ALERT SERVICE BULLETIN

222-26-115

SUBJECT: TAIL ROTOR PITCH HORN ASSEMBLY P/N 222-012-774-109, REMOVAL FROM SERVICE.

HELICOPTERS AFFECTED: Serial numbers 47006 through 47089

Figure 1: Difference Between Pitch Horn Assemblies

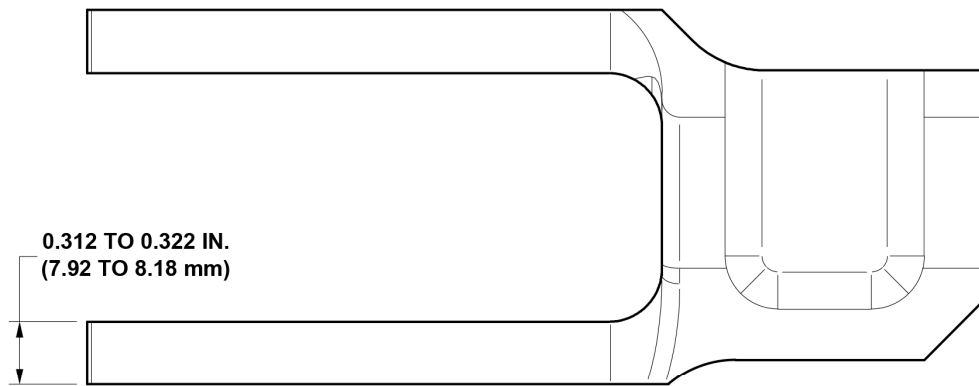
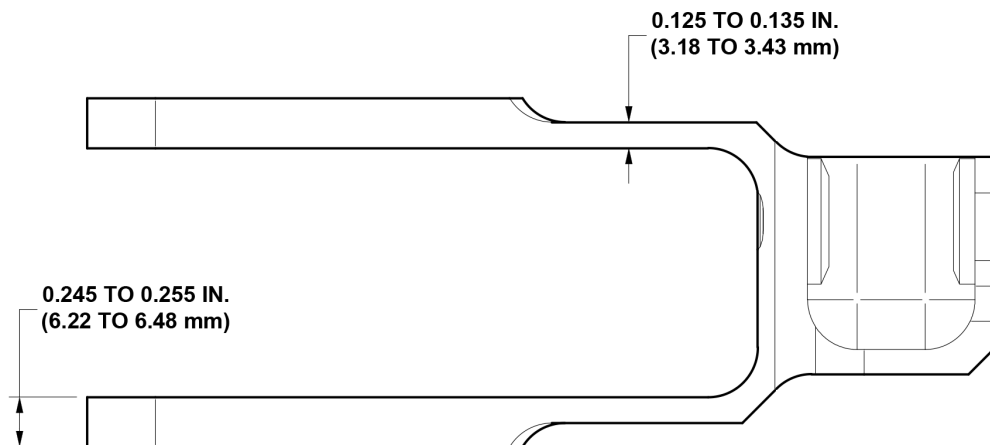
The part number of the pitch horn assembly is vibro-etched on the component. The physical differences between the 222-012-705-XXX pitch horn assembly and the 222-012-774-XXX pitch horn assembly are shown in Figure 1.

3. Remove the tail rotor pitch links P/N 230-312-001-101 (BHT-222/222B-MM-1, Chapter 65). Discard bolts P/N 20-057-5-21D.
4. Remove the tail rotor pitch horn assemblies P/N 222-012-774-109 (BHT-222-CR&O-3, Chapter 64). Discard bolts P/N 20-057-5-30D.
5. Install the tail rotor pitch horn assemblies P/N 222-012-705-105 or 222-012-705-107 (BHT-222-CR&O-3, Chapter 64) using P/N 20-057-5-32D bolts.
6. Install the tail rotor pitch links P/N 222-012-765-101 or 222-012-765-103 (BHT-222/222B-MM-1, Chapter 65) using P/N 20-057-5-28D bolts.
7. Move directional controls through full travel and check for clearance.
8. Dynamically balance the tail rotor hub and blade assembly (BHT-222/222B-MM-1, Chapter 65).
9. Make an entry in the helicopter logbook and historical service records indicating compliance with this Alert Service Bulletin.
